# SERVICE No. 534 BULLETIN

Piper Aircraft Corporation

Subject: Turbine Tailpipe Coupling Replacement

PA-31P Pressurized Navajo..... 31P-1 to 31P-7730003 Inclusive

New Turbine Tailpipe Coupling - P/N 556 053  
(See Instructions Below)

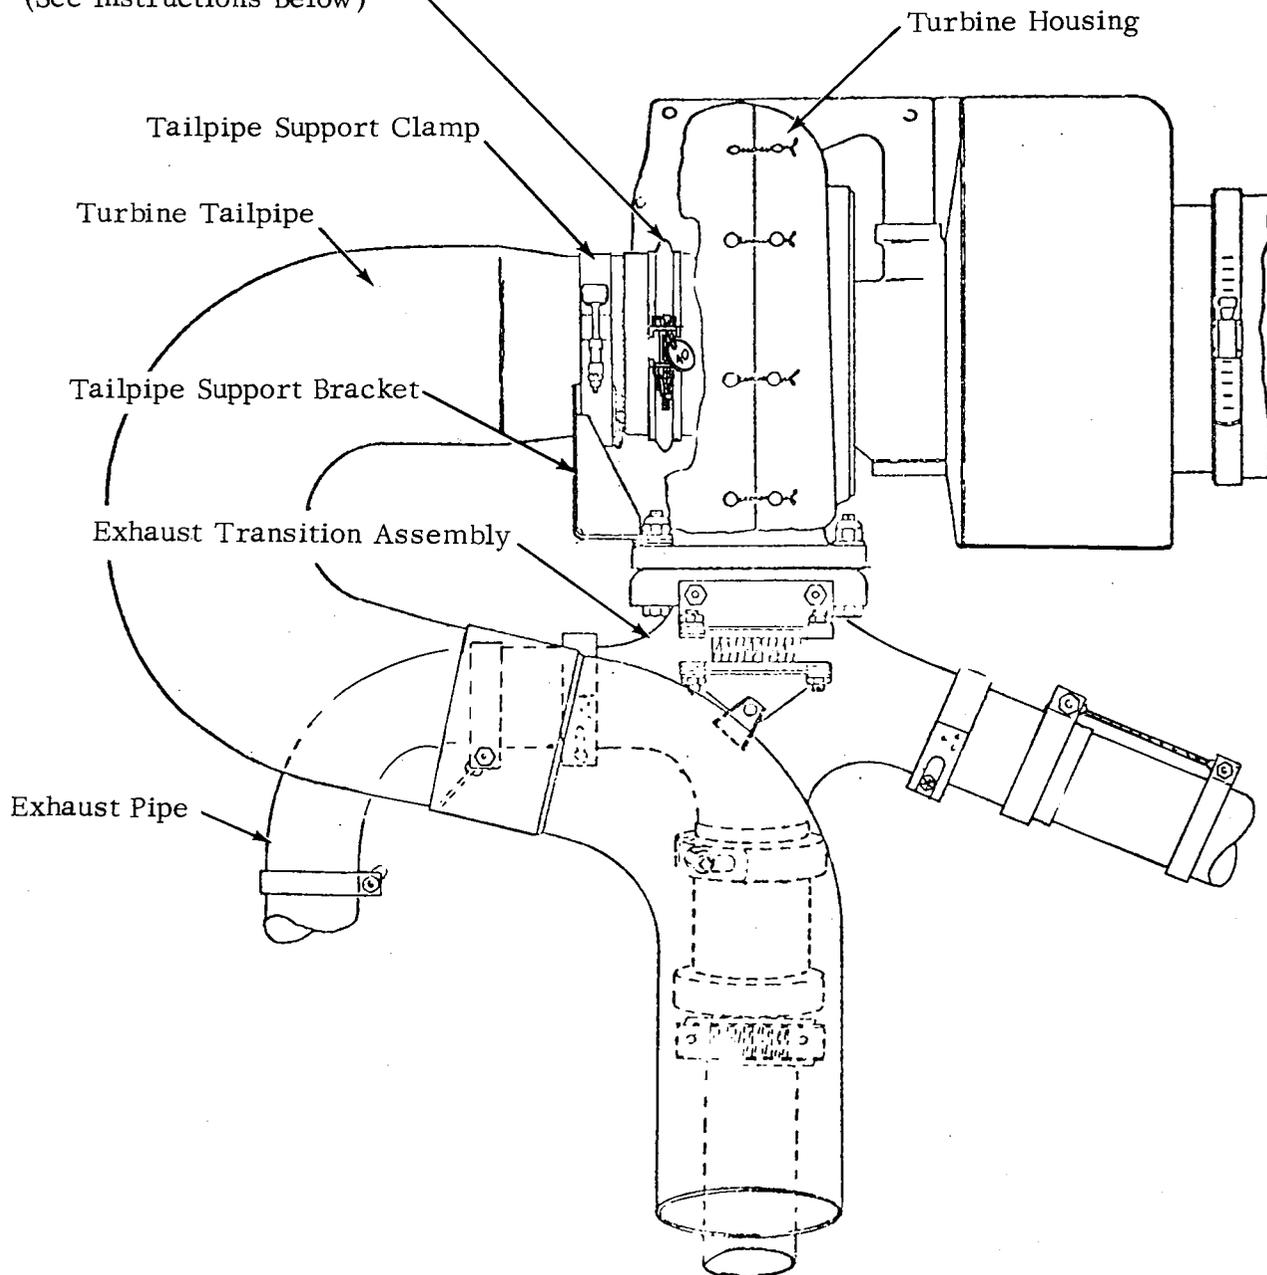
Purpose: A recent field report has been received describing failure of the turbine outlet to turbine tailpipe coupling, resulting in separation of the tailpipe from the turbine outlet. This condition could allow hot exhaust gases to escape into the engine compartment, with possible damage to cowls and adjacent powerplant system components.

This service bulletin provides material and instructions to replace the existing turbine tailpipe coupling with a new coupling, redesigned to provide a better method of clamping the mating surfaces of the turbine outlet and tailpipe, and to exhibit increased resistance to heat/vibration induced wear in this area.

1. Remove engine cowling from both engines to gain access to the turbine tailpipe couplings.
2. Remove tailpipe support clamp from both engines.
3. Remove existing couplings and install new couplings P/N 556 053 as follows:

- a. Install coupling over end of tailpipe flange, spreading clamp a minimum amount. Do not remove retaining wire from coupling.
  - b. Fit tailpipe flange to turbine flange, making certain flange faces are butted together with no gap.

- c. Position tailpipe for clearance with exhaust pipe. Slide coupling over flanges, position and tighten. Torque to 40 inch-pounds.
4. Position existing tailpipe support clamp around tailpipe and support bracket. Deflect upper end of bracket approx. 1/8 inch away from turbine housing and tighten clamp so as to preload the tailpipe flange against the turbine flange. Torque clamp nut to 25-35 in. lbs.
